**BROWNS FERRY NUCLEAR PLANT (BFN) – UNIT 1 – TECHNICAL SPECIFICATIONS (TS) CHANGE TS-431 – EXTENDED POWER UPRATE (EPU) – RESPONSE TO ROUND 23 REQUEST FOR ADDITIONAL INFORMATION (RAI) EMCB.205 AND EMCB.206 (TAC NO. MD5262)**

**RESPONSE TO ROUND 23 REQUEST FOR ADDITIONAL INFORMATION (RAI) EMCB.205  
AND EMCB.206**

**Figure 1: Steam Dryer Bottom Plan View of Support Beams**

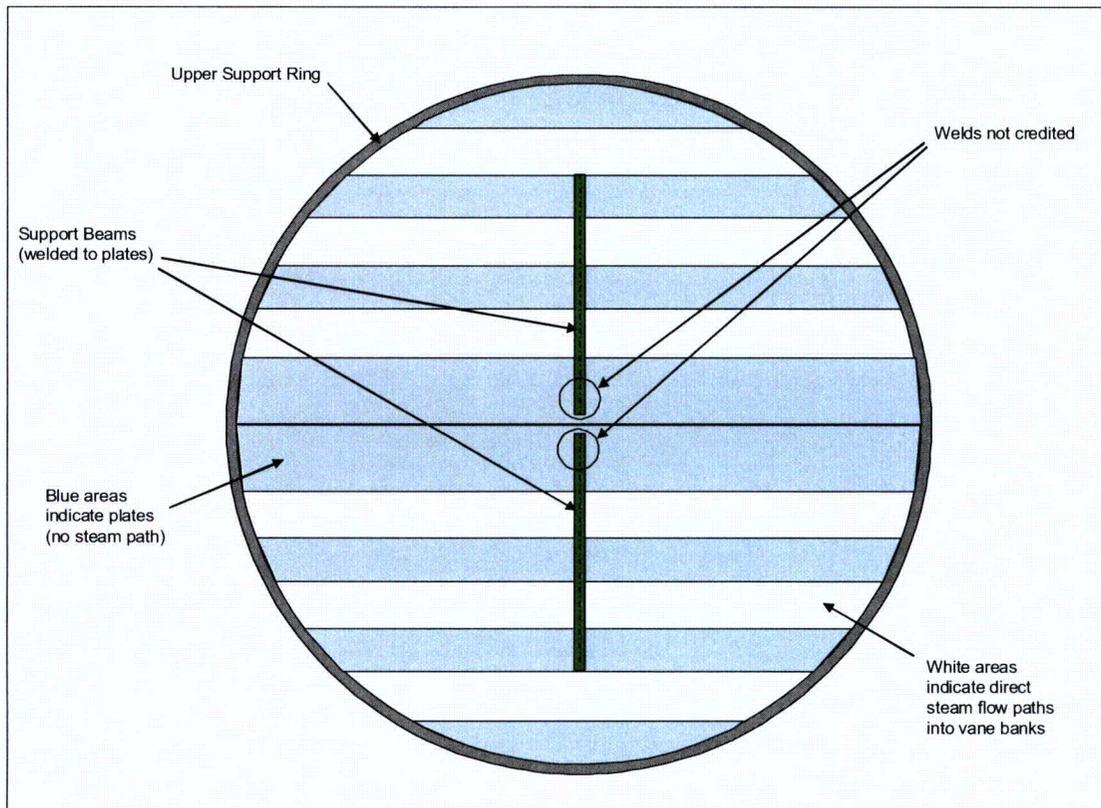
In a letter dated March 11, 2009, TVA presented the Unit 1 steam dryer support beam analysis in Enclosure 1. The submittal indicates the support beams are the secondary structural members because they play no role in providing structural integrity to steam dryer. As such the main concern related to partially unattached support beams is the generation of loose parts. TVA claims that the generation of loose parts is not a concern because the stresses in the remaining attached welds on the support beams are acceptable. Therefore, the NRC staff requests TVA to show that galloping of the unattached portion due to cross flow of the support beams is not a problem. Additionally, the licensee should address whether these welds are/will be included in the BFN inspection program.

The support beams were illustrated in Figures 1 through 3 of the March 11, 2009, submittal, "Steam Dryer Analyses Additional Information." Figure 1 is reproduced below with additional notations depicting direct steam flow paths (cover plates which were inadvertently left off the previous version have also been added). The portion of the support beam which would become a free end if no credit were taken for the welds is not in the flow path of the steam entering the steam dryer vane banks. This portion of the support beam is located adjacent to and under the steel plate beneath the vane bank and inner plenum (see Figure 3 of the March 11, 2009 submittal for details of this weld area). Accordingly, it is not exposed to significant cross flow and flow induced excitation is not expected.

In order to bound the possibility of galloping of the free end of the support beam, additional analyses were performed. For these analyses, the steam flow rate directed into the vane banks was conservatively applied across the bottom of the vane banks directed at the 14.5 inch (in) free end. This analysis follows.
